**PROPOSED STRATEGIC HOUSING DEVELOPMENT  
'THE CONNOLLY QUARTER': DESIGNERS' RESPONSE  
TO QUALITY & ROAD SAFETY AUDITS**

**OXLEY HOLDINGS LIMITED**

**PROJECT NO. 0635**

**30<sup>th</sup> SEPTEMBER 2019**

Location: Preferred Junction Option – Oriel Street Plan Layout.

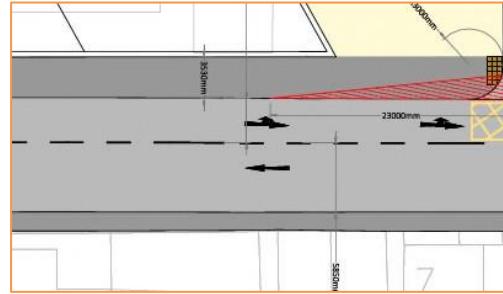
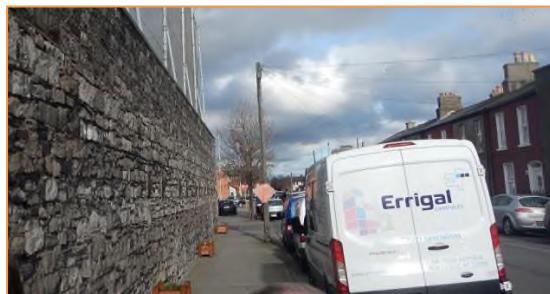
**Problem:** There is currently on-street parking on both sides of Oriel Street Lower. The drawing shows that parking will be removed on the development side of the street. This may lead to locals parking partially on the footpath if they do not have alternative parking facilities. This could lead to hazards for pedestrians and blocking of sightlines for drivers exiting the new development.

**Recommendation:** It is recommended that a parking review be carried out to ensure that enough parking space is retained for local residents. If sufficient capacity is not provided, then alternative additional parking should be provided, and prohibitive measures be provided to avoid parking on footpaths or close to the proposed access.

**Response:** The applicants are satisfied to undertake a Parking Review locally as recommended. Oriel Street is 125 m long from Oriel Hall to Commons Street and accommodates 25 parallel parked vehicles on either side of the road along with some further vehicles between Oriel Hall and Seville Place. The sightline requirements for the proposed access will result in the loss of 5 no. spaces on the north side of the street i.e. about 10% of the on-street total. Off-street in-courtyard parking is provided for the DCC residential development on the southwest end of the site which will be unaffected by the development, as will the on-street parking on Oriel Hall. In that context the overall impact on on-street parking is considered to be minimal.

Location: Preferred Junction Option – Oriel Street Plan Layout.

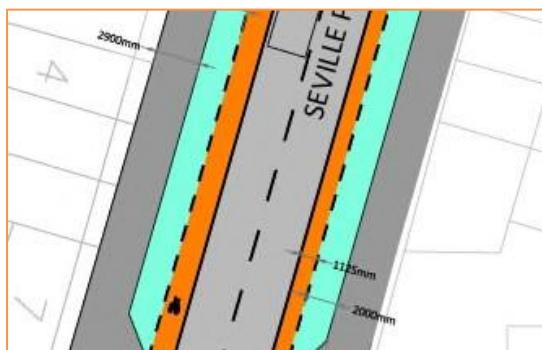
**Problem:** It is envisaged that the proposed development will attract cyclists from the Amiens Street direction that will travel south-west on Seville Place and turn right onto Oriel Street Lower. Currently cyclists have to enter the carriageway to turn right or travel to the toucan crossing on the opposite side of the junction. It is unlikely that cyclists would undertake the latter due to the extra journey time and the former would put them at greater risk of being struck by a passing motorised vehicle.

**Recommendation:** It is recommended that the Seville Place /Oriel Street Upper/Oriel Street Lower junction be signalised with a toucan crossing facility on the northeastern leg of the junction. Any adjustments to this strategic regional road should take into account knock on effects at other junctions as part of an overall traffic review as excessive delays at one location could lead to other safety issues at adjacent junctions.

**Response:** The applicants are satisfied to work with the Roads Authority to investigate the traffic impact of any signalisation on the Seville Place - Oriel Street junction with a view to introducing a Toucan Crossing as recommended.

*Figure 5: Proposed Connolly Station Drop Off Area*

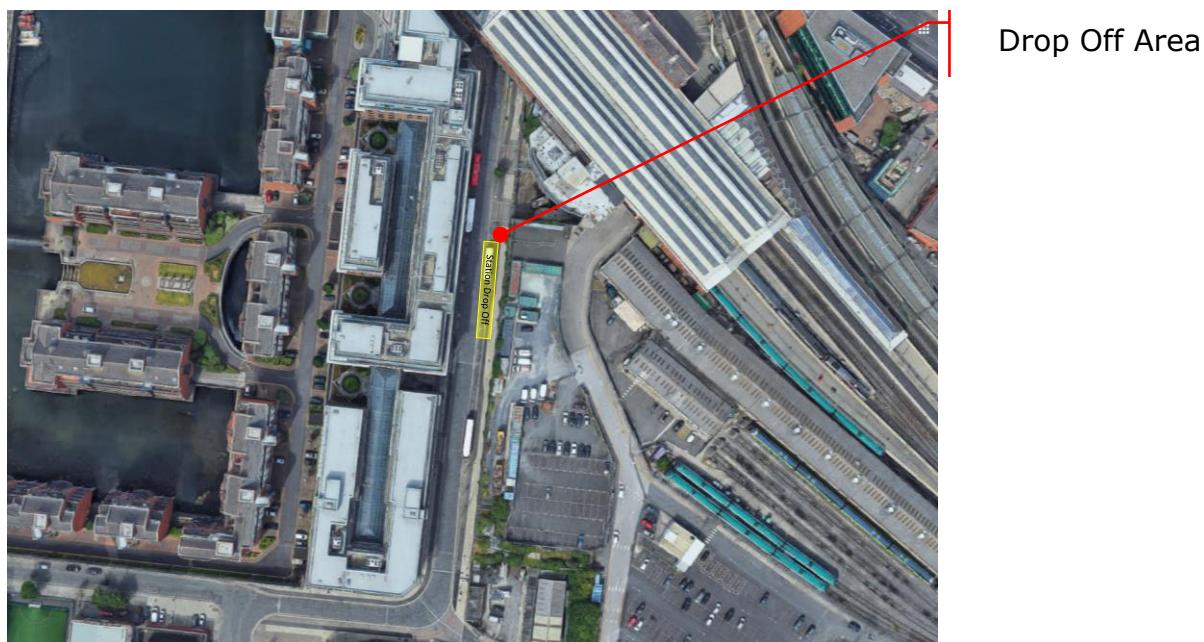
**Problem:** The existing Connolly Station Car park will be replaced by a basement carpark. There is currently no provision for a drop off area. This will lead to drivers stopping in traffic lanes, mounting footpaths or cycle tracks.

**Recommendation:** It is recommended that a drop off area be provided along Sheriff Street Lower.

**Response:** There is ample room on either side of Sheriff Street to accommodate a Drop Off Area. It is proposed that an area on the north side, close to the bridge be provided as shown in Figure 5 below.

*Figure 7: Proposed Dublin Bikes Stand Location*

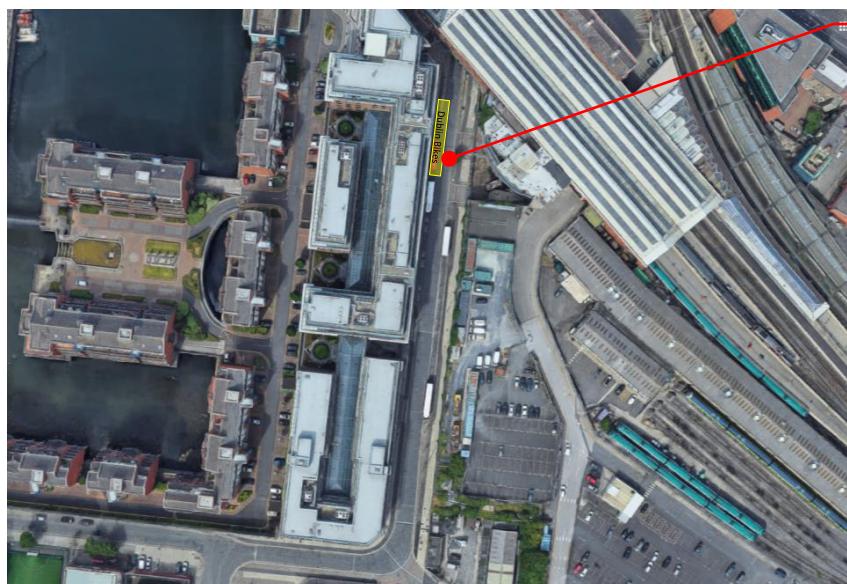
**Problem:** With increasing bicycle usage, additional bicycle parking will be required for Connolly Station. A lack of bicycle parking spaces could lead to cyclists locking bicycles to items of roadside furniture which could create hazards for pedestrians.

**Recommendation:** It is recommended that a review on the requirements for bicycle parking associated with Connolly Station be undertaken and ample bicycle parking to be provided as a result.

The applicants will liaise with the Dublin Bikes providers in relation to introducing a facility on Sheriff Street Lower at a location close to the railway station and perhaps at a point to be vacated by relocating busses currently parking in the area – see Figure 7 over.

**Location:** Sheriff Street Lower, existing Cycle Track.

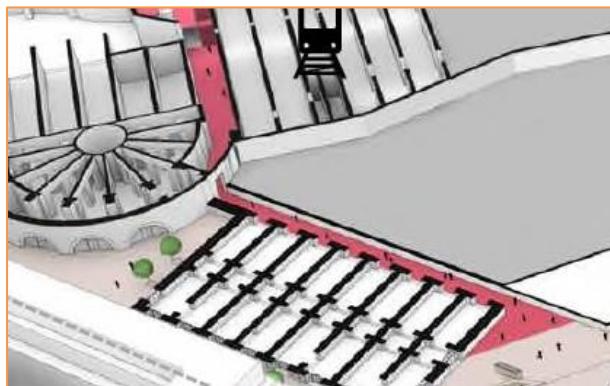
**Problem:** The existing cycle track along Sheriff Street Lower at the Amiens Street end has a steep vertical alignment at the access to the Irish Rail property and may be difficult for cyclists to maintain balance, particularly younger cyclists.

**Recommendation:** It is recommended that the alignment of the cycle track be reviewed and that the need for the access to Irish Rail property that is currently locked be reviewed.

**Response:** The applicants are of the view that it will not be possible to secure an agreed closure of the occasional vehicular access to the IÉ property. In that context it is expected that a reduced level will have to be maintained at the access point off Sheriff Street Lower.

However, it would be possible to undertake a vertical realignment of the cycle track so as to ensure a smoother transition in levels and to ensure that the maximum vertical gradient is less than the 5% limit set out in the National Cycle Manual. The applicants are satisfied to undertake the design and construction of this work in consultation with the Roads Authority.

*Figure 8: Potential Pedestrian Link to Station*

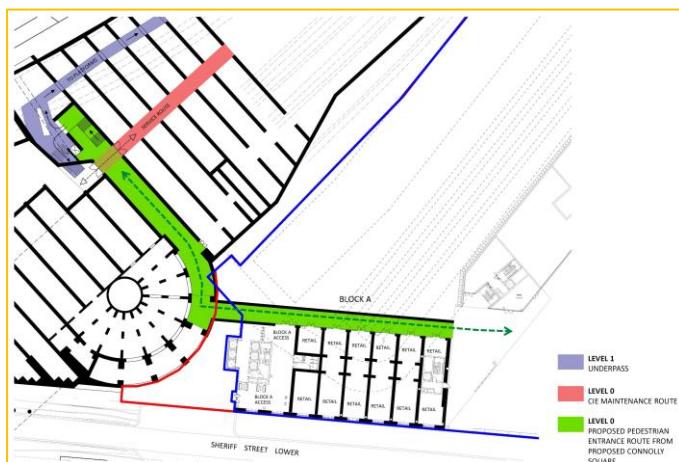
**Problem:** There appears to be access to the platforms of Connolly Station at two levels. It is unclear if the accesses are wide enough to cater for the volumes of people that may use the station at the same time as trains arrive/depart. Inadequate space for pedestrians may lead to squashing of vulnerable road users such as the mobility impaired, the elderly and the young.

**Recommendation:** An analysis should be carried out of likely user volumes of Connolly station from and through the new development and adequate route widths should be provided with suitable ventilation and lighting.

**Response:** The applicants are in detailed discussions with Iarnród Éireann in relation to providing a pedestrian link between the proposed development (at Connolly Square) and the DART commuter platforms in Connolly Station. An initial route for the proposed connection is shown in Figure 8.

The provision of the proposed link will be included in a separate S34 planning application to DCC as part of a wider commercial application and does not form part of this SHD planning application.

*Figure 10: Pedestrian Crossings at Busárus – Connolly Amiens Street*

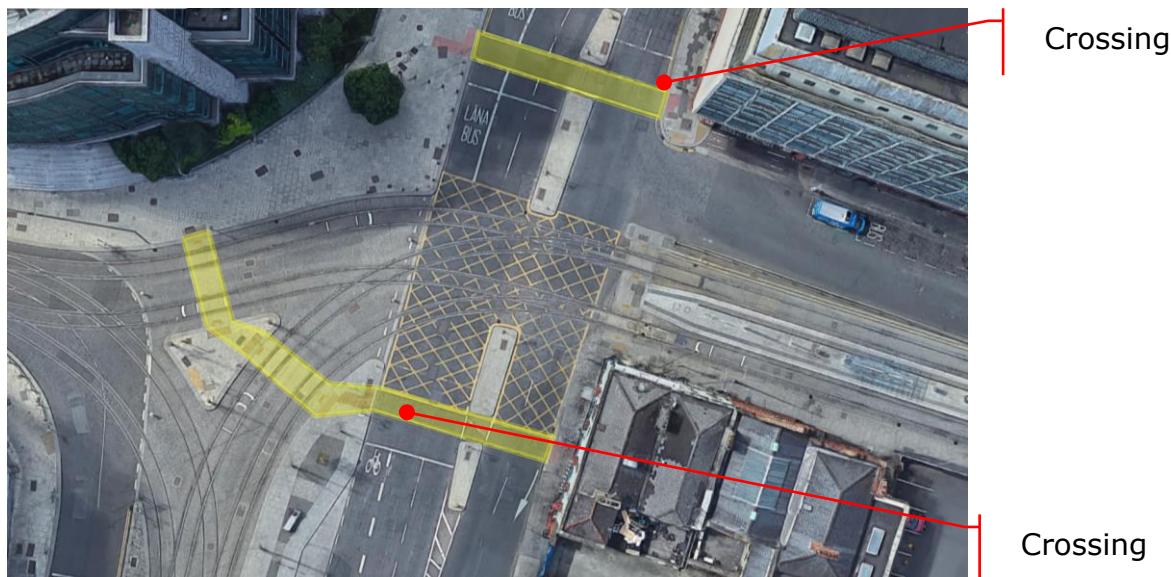
**Observation IV:** Pedestrians were observed crossing Amiens Street between Connolly Luas stop and Busárus Luas stop at numerous locations. However, these were able bodies persons. Signal controlled pedestrian crossing facilities are available for the mobility impaired should they choose to use them. As it is anticipated that footfall will increase with the proposed development then the size of the crossing may need to be increased.

**Response:** The designers note the observation and note further the existing crossing points between Connolly & Busárus – Figure 10. Notwithstanding the foregoing the applicants will raise same with the Roads Authority.

Figure 11: Proposed Toucan Crossing at Foley Street

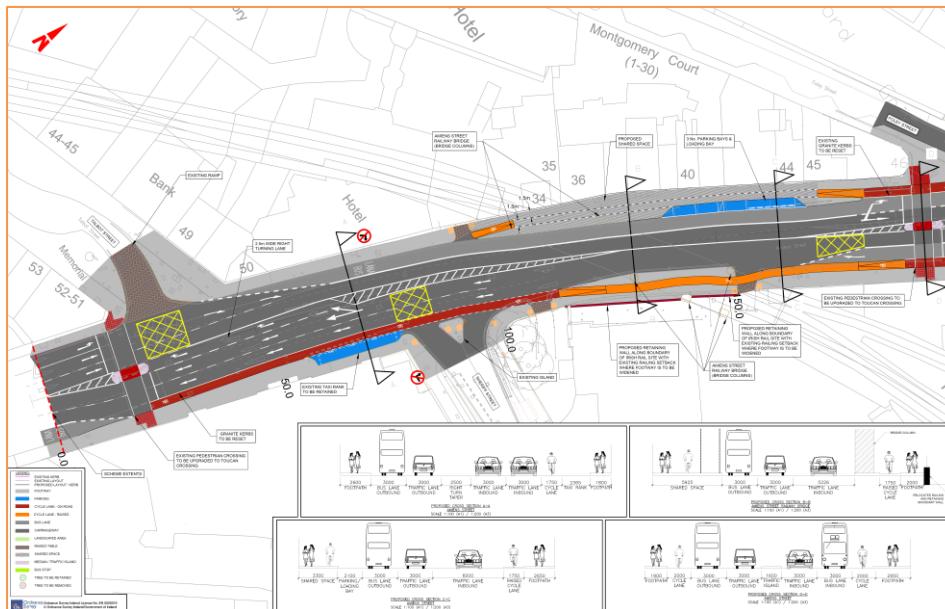
**Observation V:** The pedestrian crossing of Amiens Street at the Talbot Street junction is only on the city centre side of the junction. It is anticipated that with the construction of the proposed development there will be a greater desire line for pedestrians to cross on the north side of the junction to get to Talbot Street and onwards to the O'Connell Street area. Such an upgrade may be included in the core bus corridor scheme.

**Response:** The designers and applicants are aware of proposals under the Clontarf to Amiens Street Cycle Scheme to enhance the stretch of Amiens Street between the junction with Talbot Street and Foley Street (and indeed wider afield as far as

Clontarf). Figure 11 below is an extract from the approved Part VIII proposals for the scheme and shows a new toucan crossing to be provided at the Foley Street junction in addition to the Talbot Street junction. The designers and applicants are of the view that this adequately addresses the audit team's observation.

Drawing 0635-OCSC-XX-XX-SK-C-0008 S2 P01, Preferred Junction Option – Oriel Street Plan Layout.

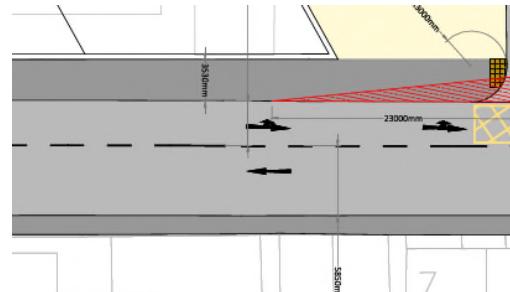
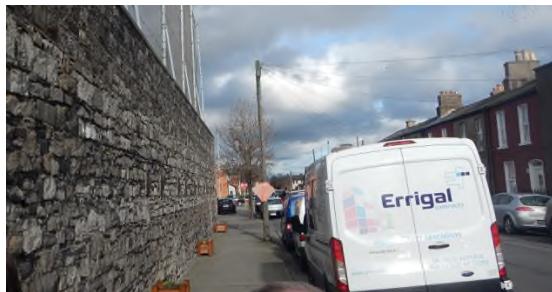
There is currently on-street parking on both sides of Oriel Street Lower. The drawing shows that parking will be removed on the development side of the street. This may lead to locals parking partially on the footpath if they do not have alternative parking facilities. This could lead to hazards for pedestrians and blocking of sightlines for drivers exiting the new development.

It is recommended that a parking review be carried out to ensure that enough parking space is retained for local residents. If sufficient capacity is not provided, then alternative additional parking should be

provided, and prohibitive measures be provided to avoid parking on footpaths or close to the proposed access.

Drawing 0635-OCSC-XX-XX-SK-C-0008 S2 P01, Preferred Junction Option – Oriel Street Plan Layout.

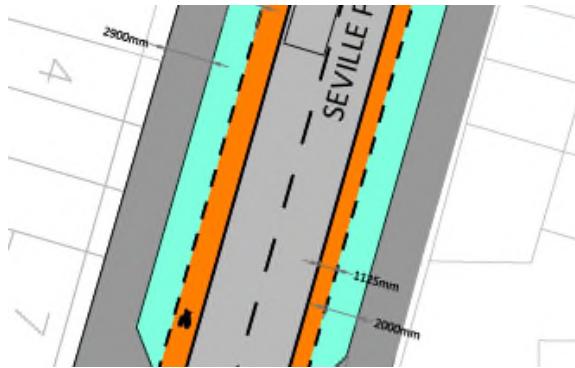
It was observed during the site visit that there is no buffer zone between parked on-street cars along Seville Place and the on-road cycle lane. A replica situation is presented in the drawing. This could lead

to collisions between cyclists and opening car doors of parked vehicles or cyclists losing control as they swerve to avoid opening doors. The Audit Team acknowledge that there is limited road space available.

It is recommended that an assessment of the footpath width (2.9m) be undertaken relative to its existing and future use to see if the footpath could be reduced in width to enable a buffer zone to be provided between parked vehicle and cyclists. It was observed that there is a large amount of street furniture along Seville Place which may reduce the effective width of the footpath unnecessarily.
